MILLWORK SHOP DRAWINGS FOR:

SAMPLE COMMERCIAL PROJECT

PROJECT NUMBER: 26003
SUBMITTAL: 7/23/2026

WORK ROOM 106 ELEV & SECTION
VIEW 1

4.3 Work Room 106 Island Elevation View
Scale : 5/8" = 1'

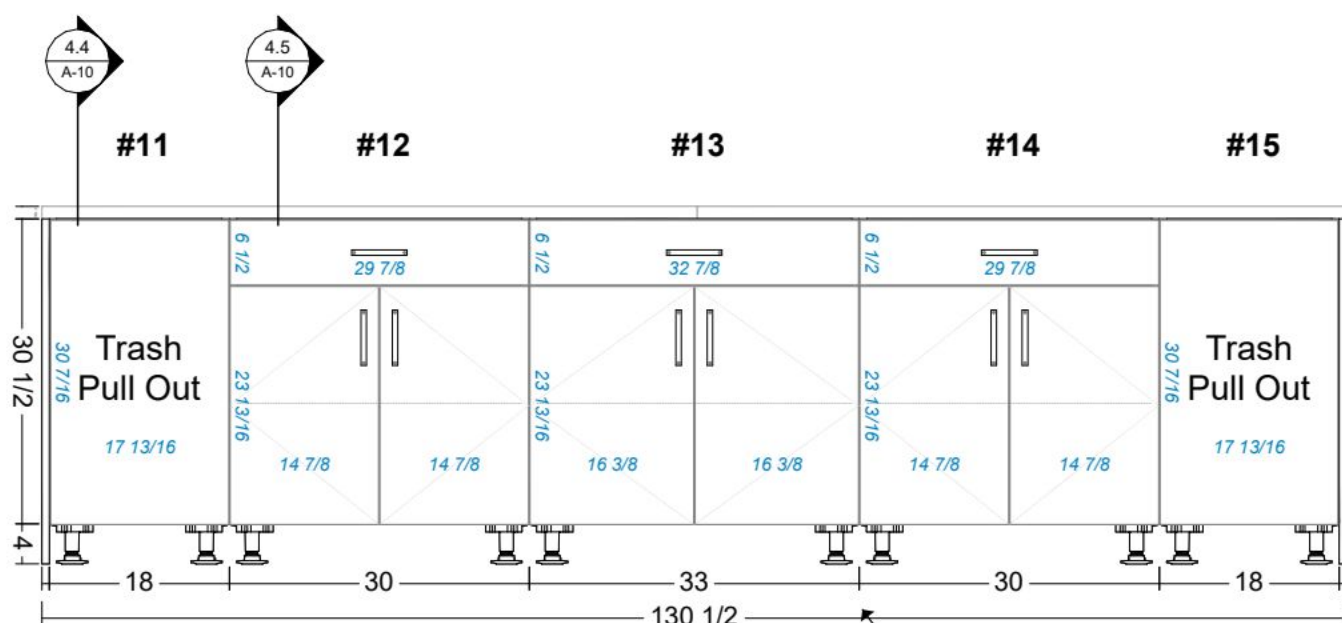
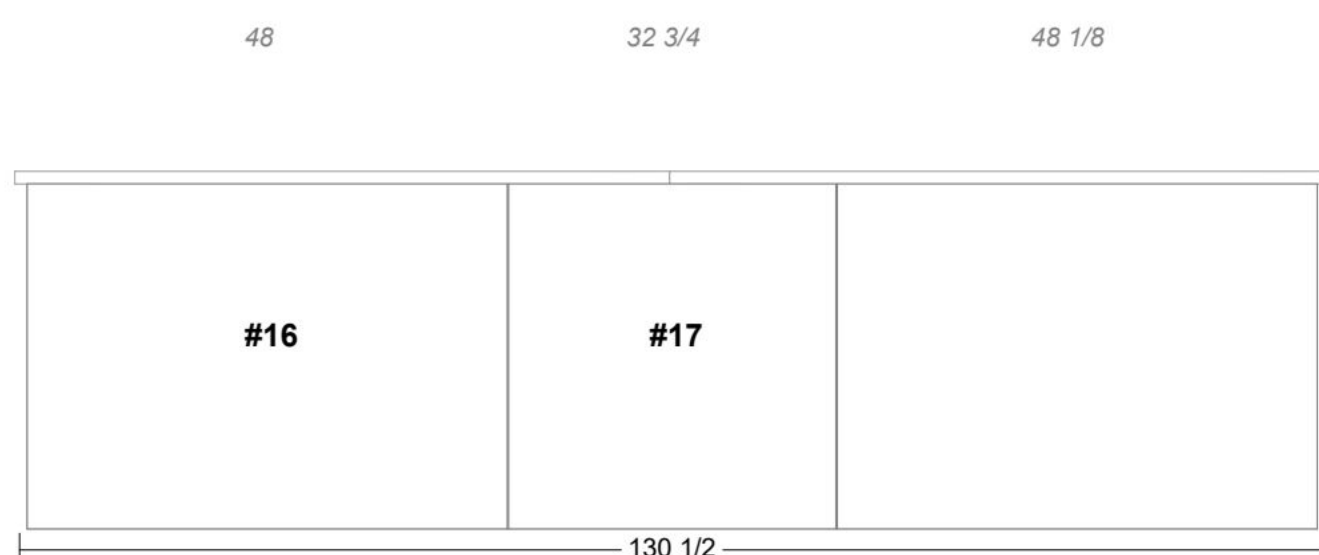
Note: Finished ends previously not included in measurement, if 129 is important, we can reduce middle by 1.5". This way Finished Ends hide door front
